Spaulding Rehabilitation Hospital

RE: Amendment of Byproduct Material and License Number 20-20615-01

License Number 20-20615-01

FACILITY DIAGRAM
Massachusetts Rehabilitation Hospital
Nuclear Cardiology Department

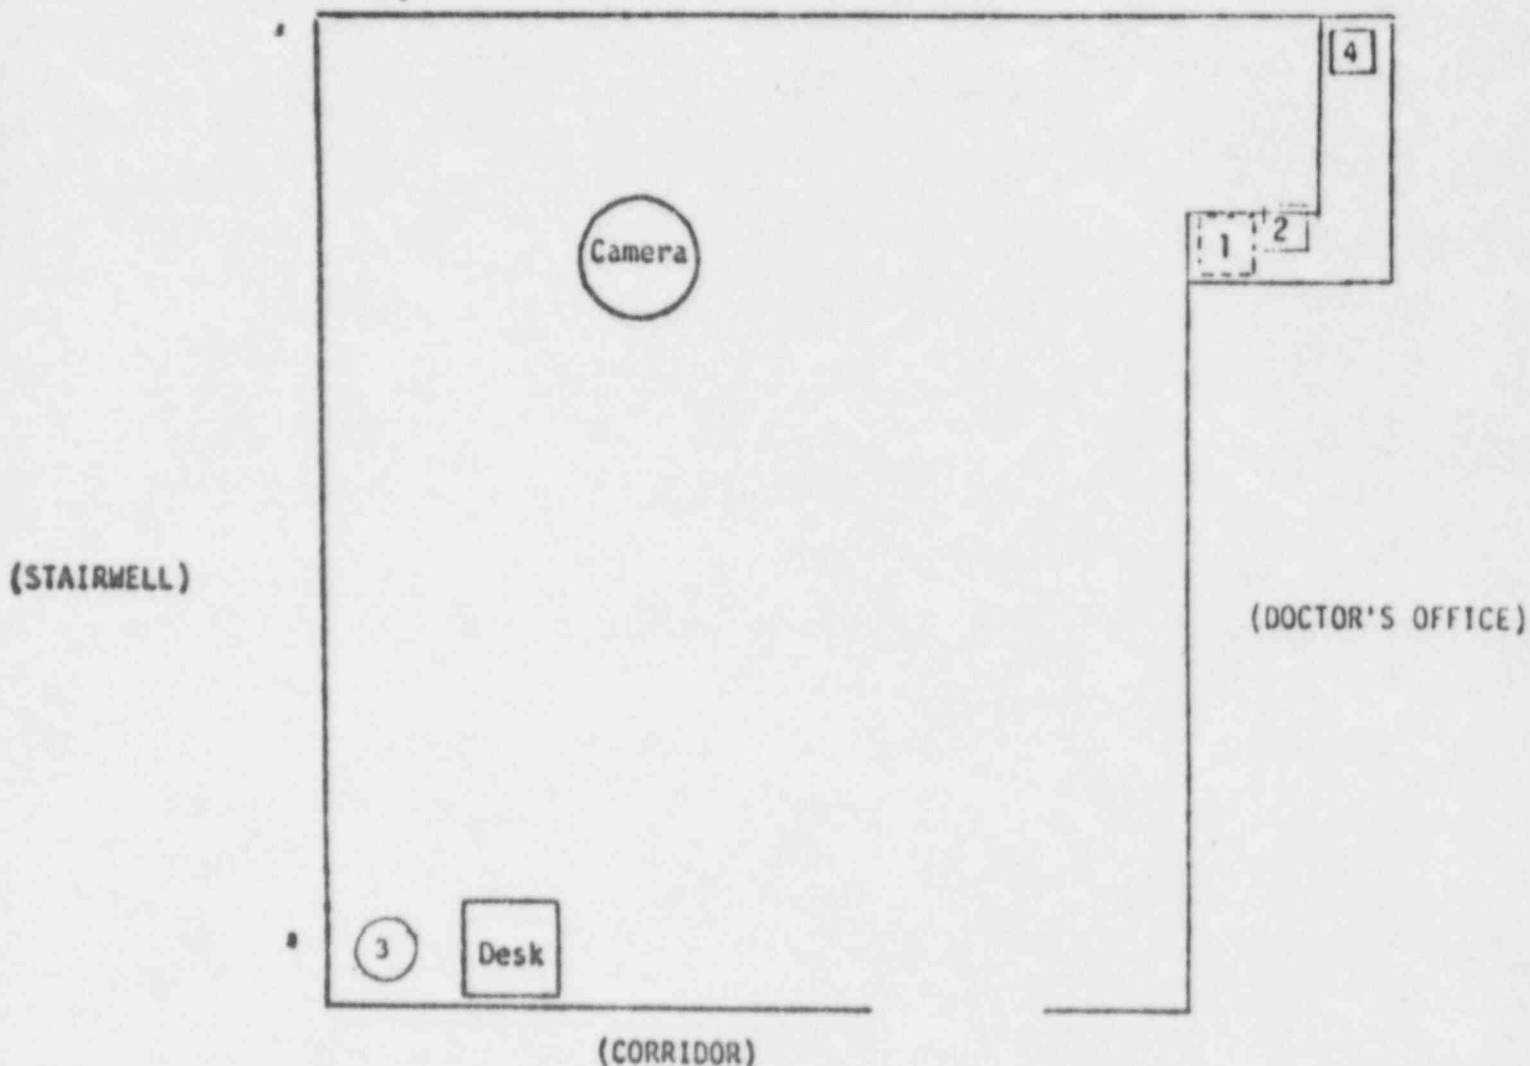
Please note a change in the sink location from the original application. (diagram of facility attached)

- NOTE: 1. Long and short lived isotope storage, surrounded by 2 inch thick lead bricks, approximately 10"x12"x12".
2. Undercounter radioactive waste and decay-in-storage, 1/8" thick lead, 10"x14"x12".
3. Sink
4. Dose calibrator
